SUBJECT: Transmittal of Responses to AP1000 DSER Open Items

**AP1000 Design Certification Review
Draft Safety Evaluation Report Open Item Non-Proprietary Responses**

AP1000 DESIGN CERTIFICATION REVIEW

Draft Safety Evaluation Report Open Item Response

Figure 15.2.7-1-1 ADS 4 Flow Quality

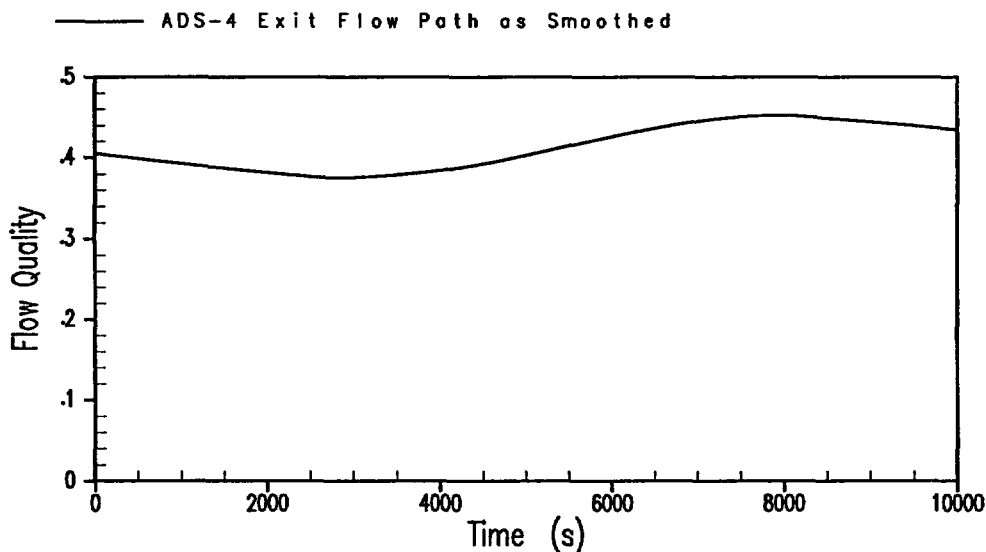
Please provide the following information regarding the boron concentration analysis given in DCP/NRC1612 entitled "Transmittal of Westinghouse Response to Boron Precipitation during LTC Phase" dated August 15, 2003:

The simplified analysis used in the longer-term assumes steady-state conditions, such that the RCS injection, core inlet / outlet and ADS 4 vent flows are all equal. The core inlet temperature vs time is shown on Fig 5 of our 8/15/03 response. The simplified model is applied at fixed times such that the results at any time are independent of the calculations at other times. For the purposes of determining the plant performance after the end of the detailed WCOBRA-TRAC analysis (at 3.5 hr) only a few times are required to follow the slowly changing conditions. The plant conditions change slowly during recirc because the injection supply is essentially constant and the decay heat is slowly decreasing. Note that in the core boron concentration calculations,

some margin has been added to the ADS 4 vent qualities; for example at 6 hour the simplified model calculates a ADS 4 vent quality of 34.5%, however 40% is used in the core boron calculations.
